VILLAGE OF CALDWELL
NOBLE COUNTY, OHIO
PRISON PUMP STATION

ADDENDUM #2

AUGUST 20, 2026

THRASHER PROJECT #T20-11309

VILLAGE OF CALDWELL NOBLE COUNTY, OHIO PRISON PUMP STATION	SHEET No. 2
PROPOSED PUMP STATION SITE PLAN

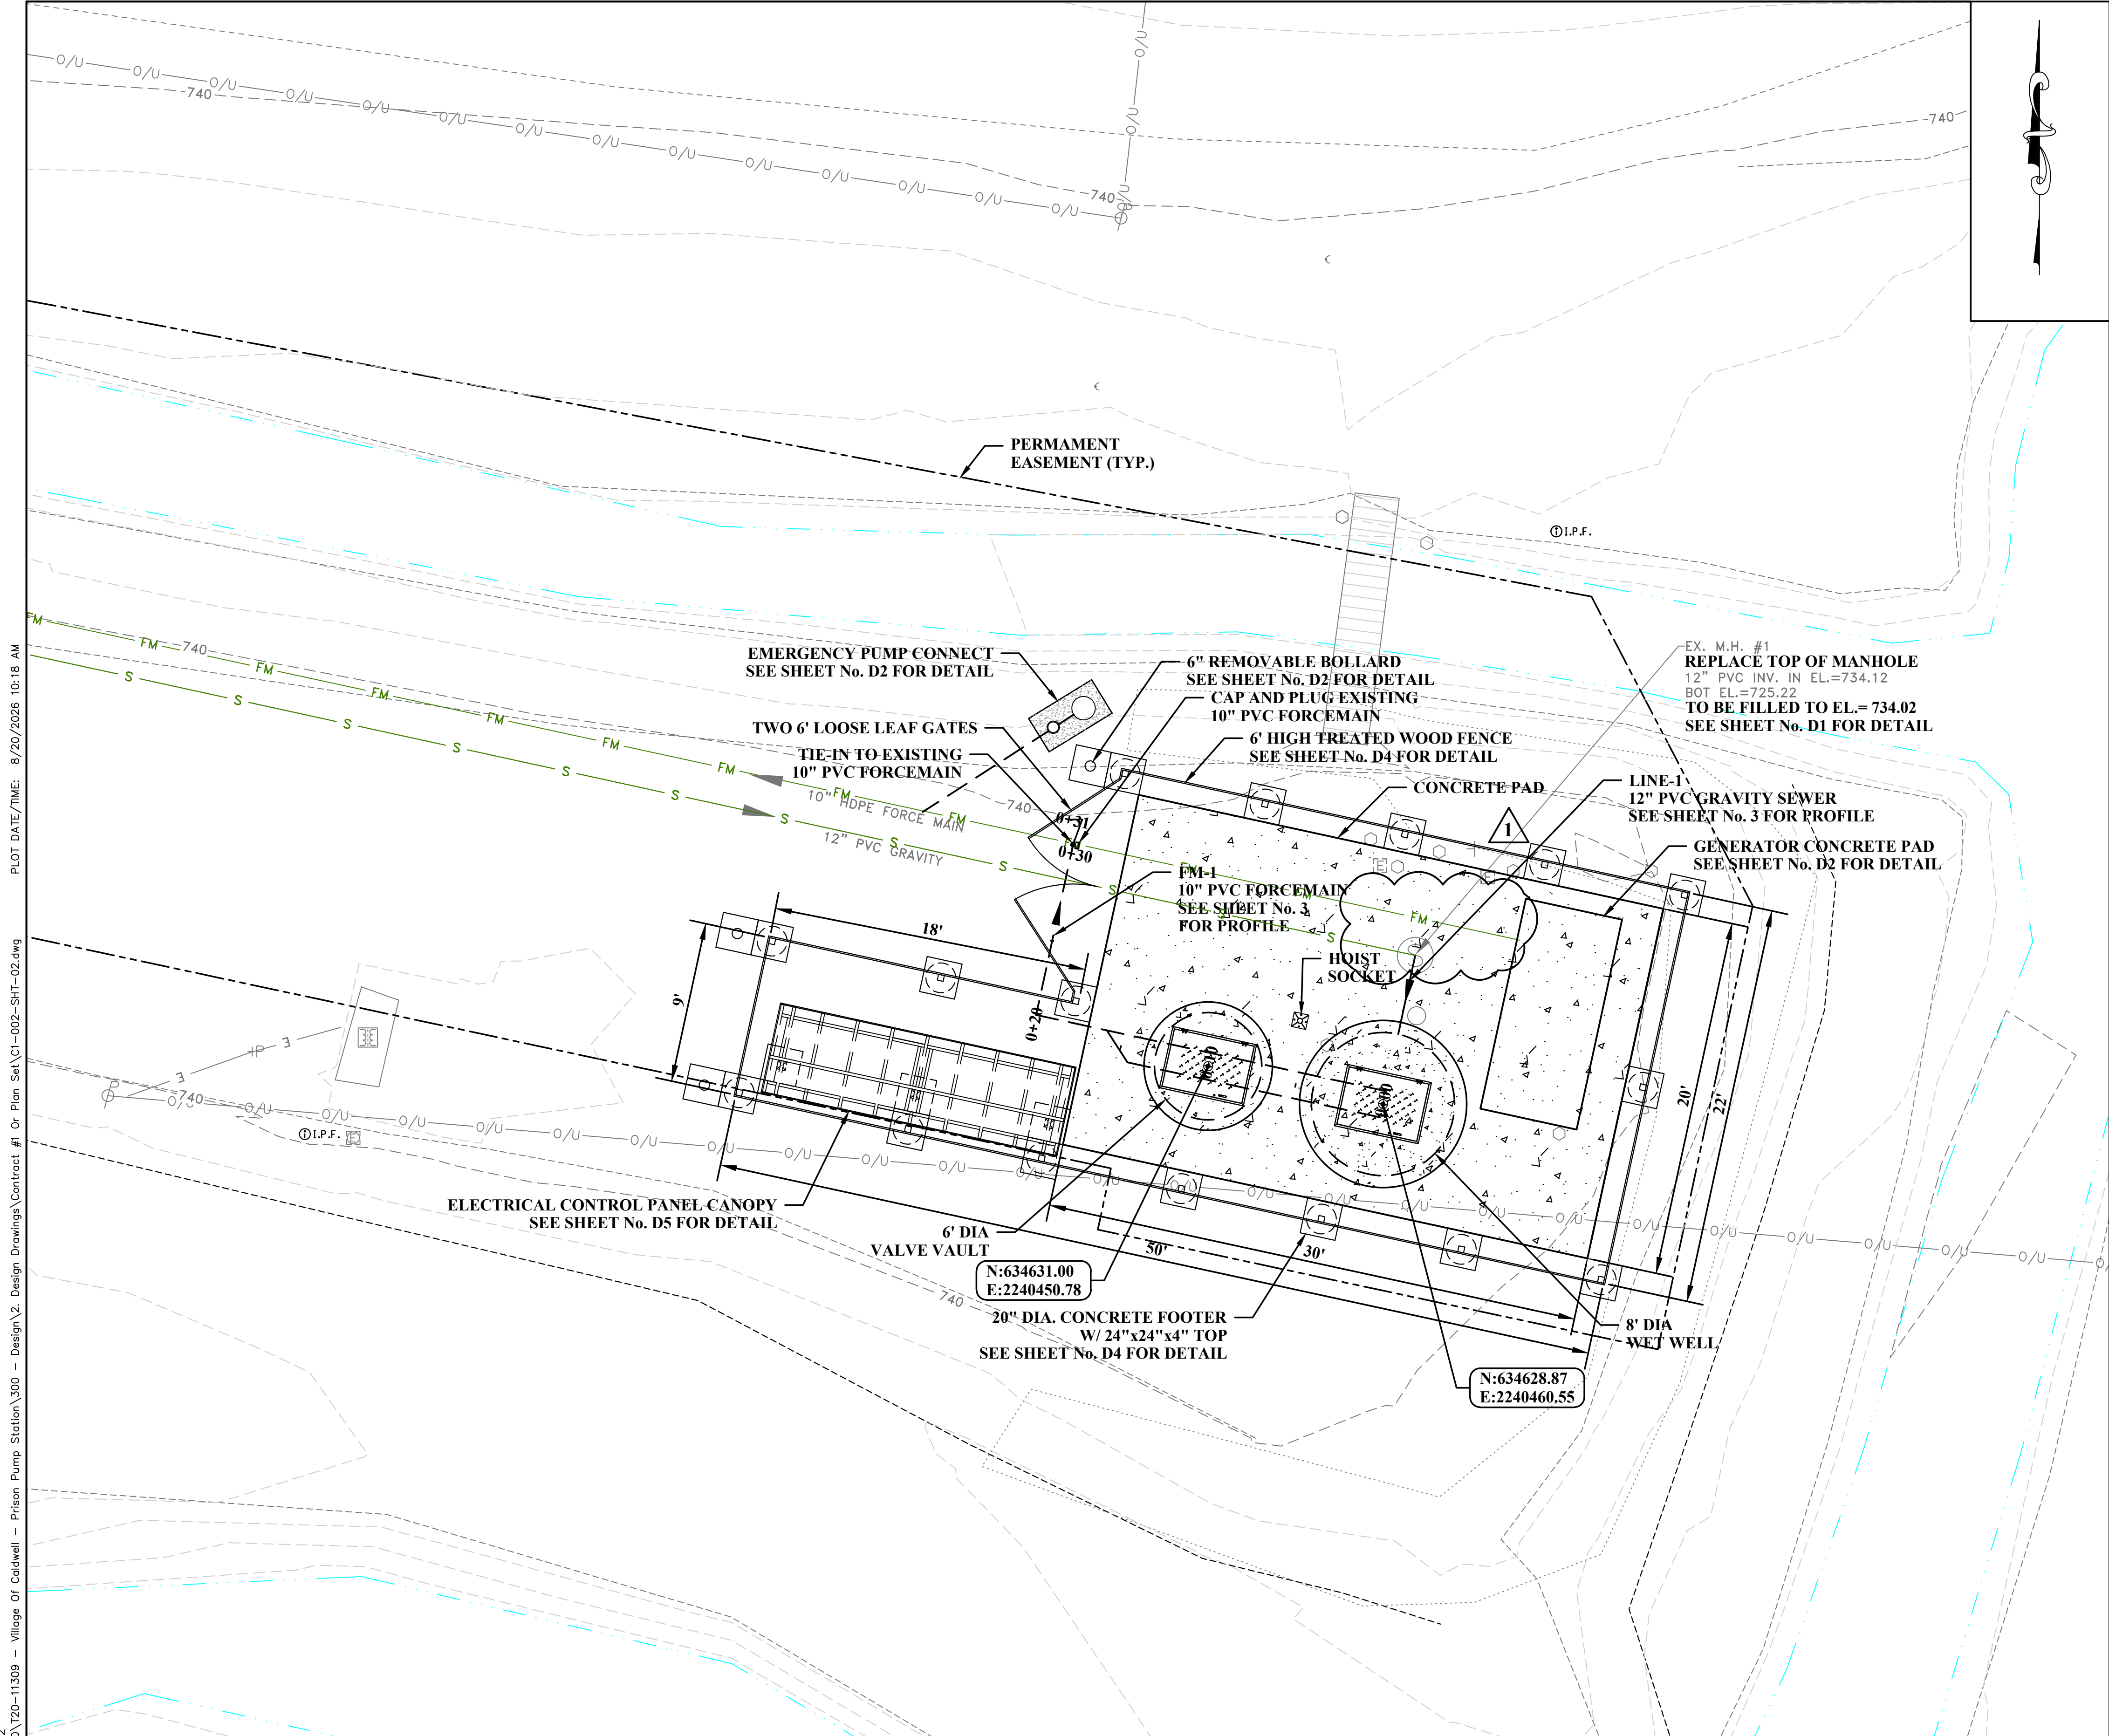
ADDENDUM #2

ELECTRICAL SITE PLAN

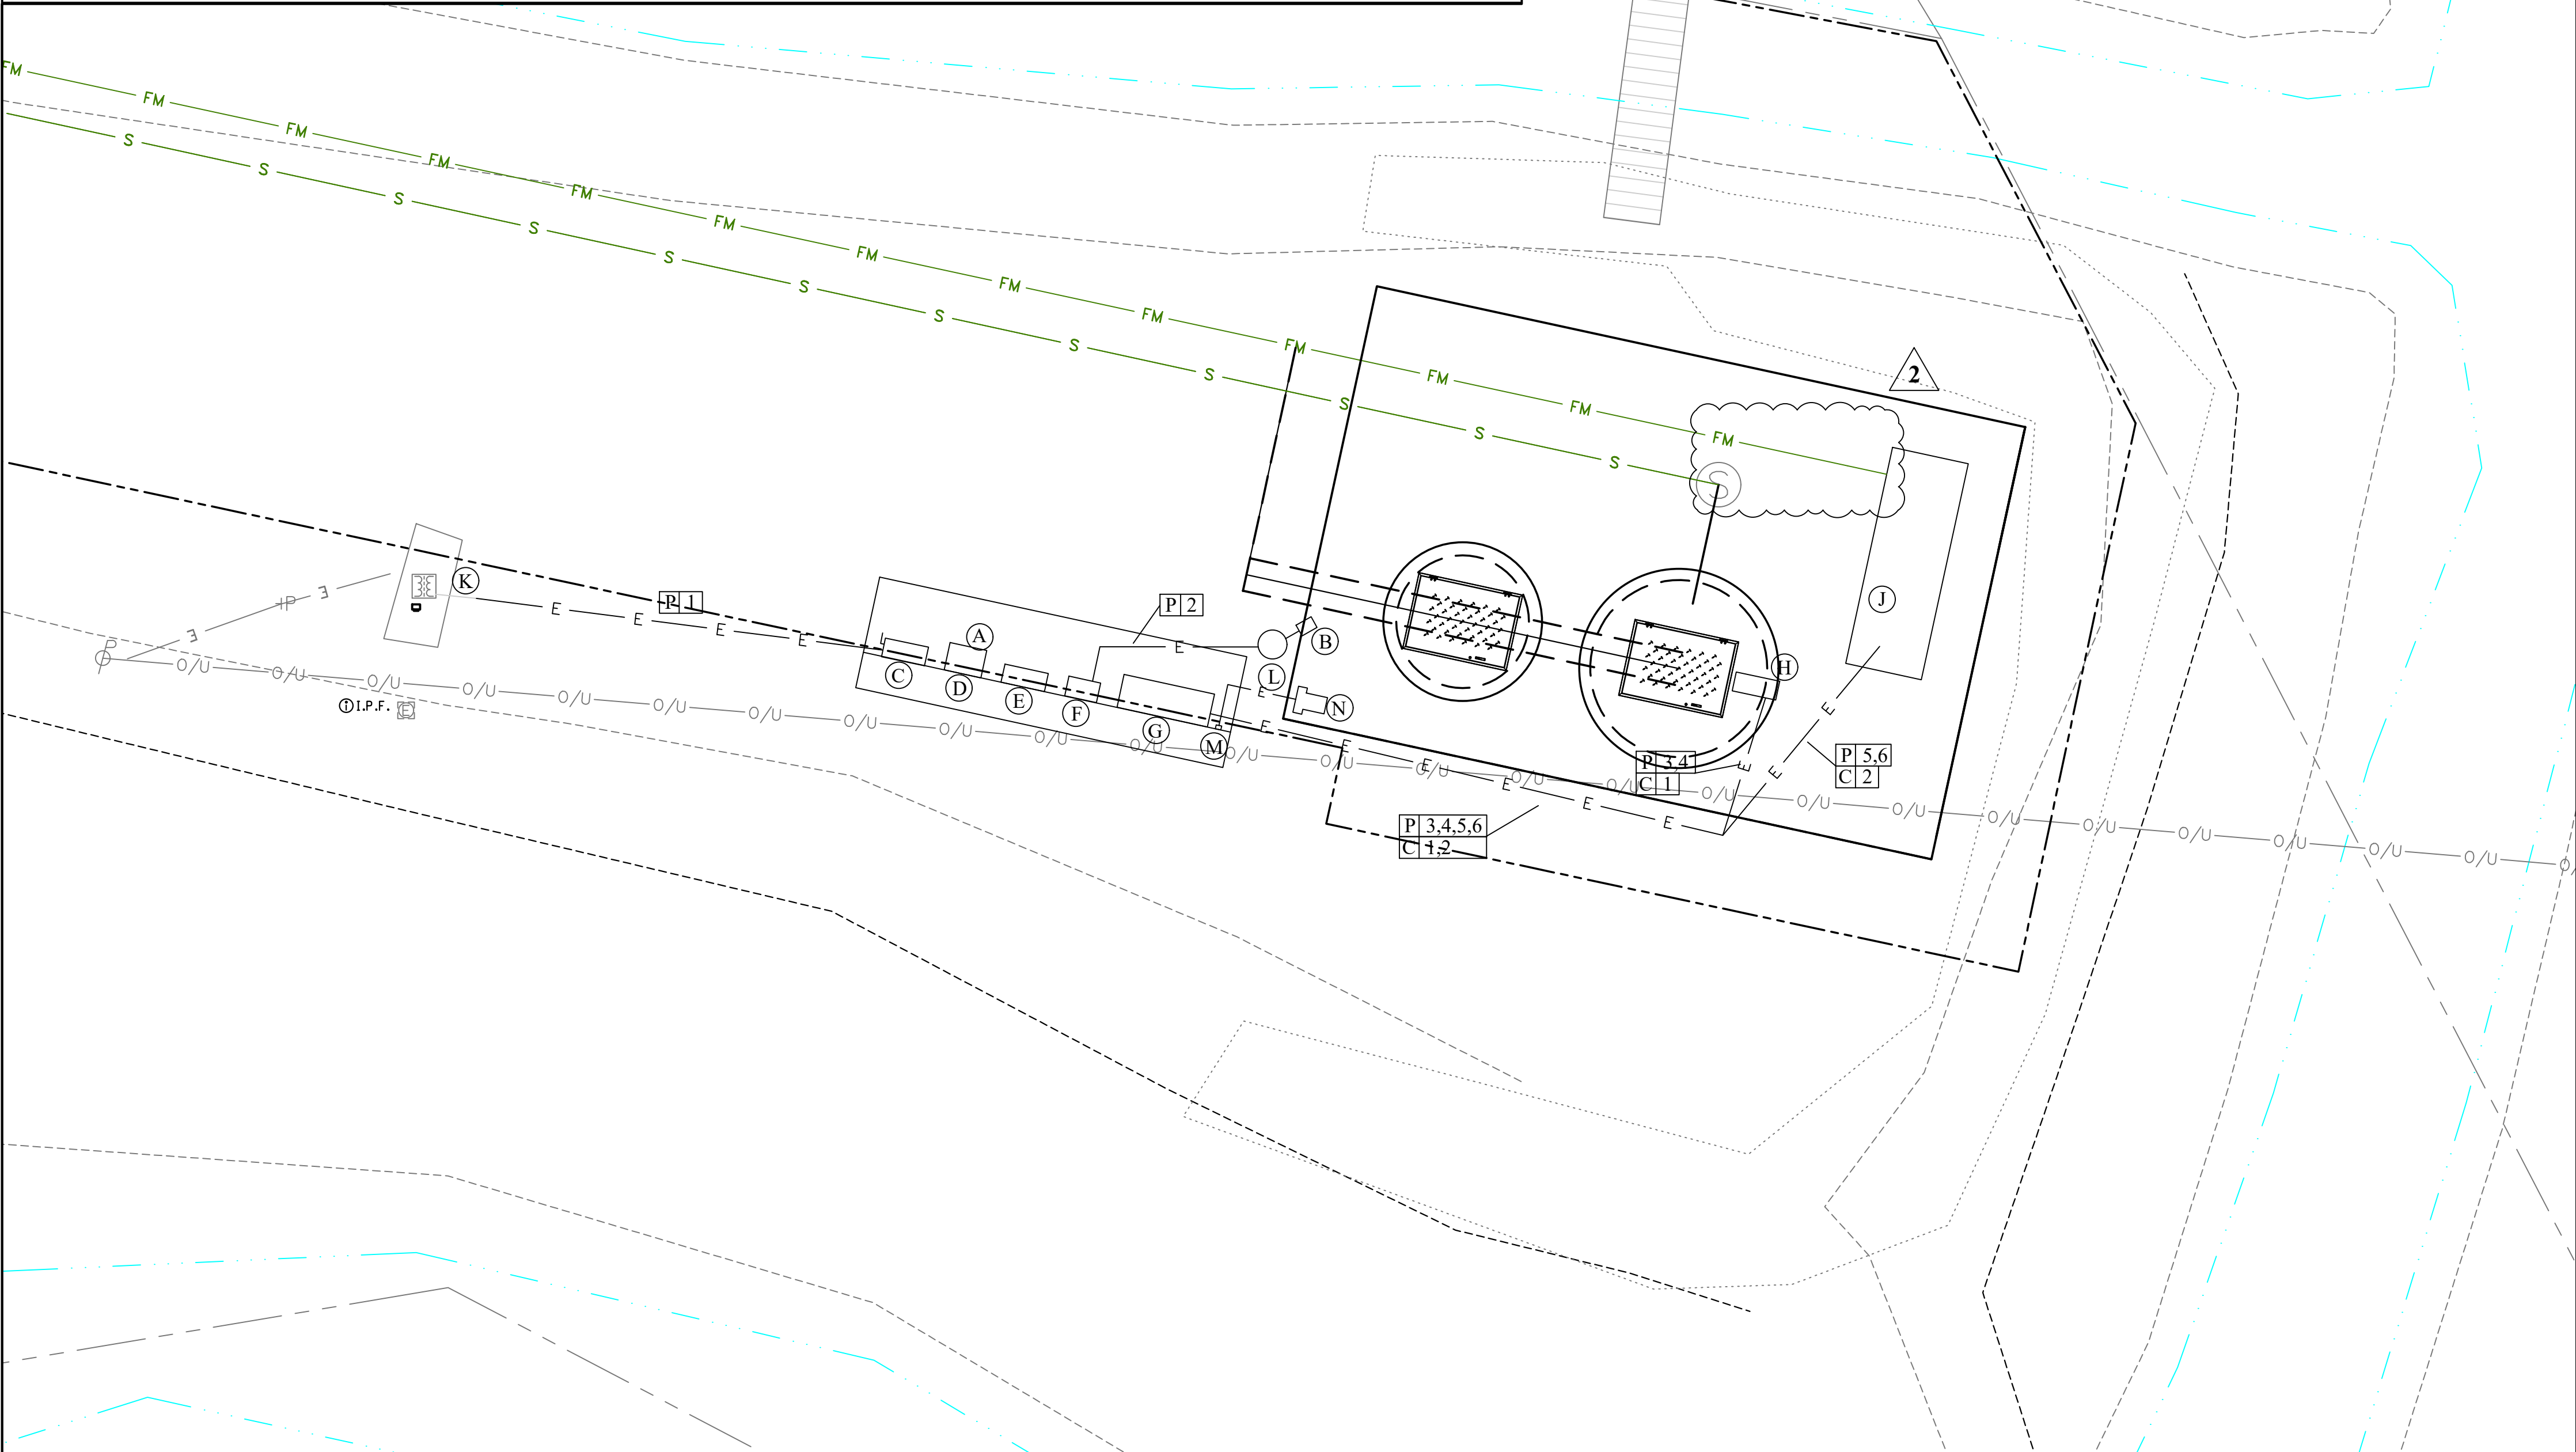
PLC Cabinet at Lift Station (Shown on Drawing E3 as Telemetry Panel) [R]

- Power 2 #12 and 1 #12 Gnd via conduit [J] as shown from feed panel [S]
- Control 16 #16, 6 STP via conduit [V] as shown from VFD panel [T]
- Communication 2 Cat 6e via a new conduit from VFD panel [T]
- Switched Power 2 #14 and #14 Gnd via a new conduit from Fog Buster (Shown on Drawing E2) [N], wired to a new dedicated receptacle fused down for the Fog Buster motor load
- Control 20 #16, 2 STP via new conduit to Stainless Junction Box [X]
- Factory provided antenna cable via conduit [DD] as shown from antenna mounting location [CC]
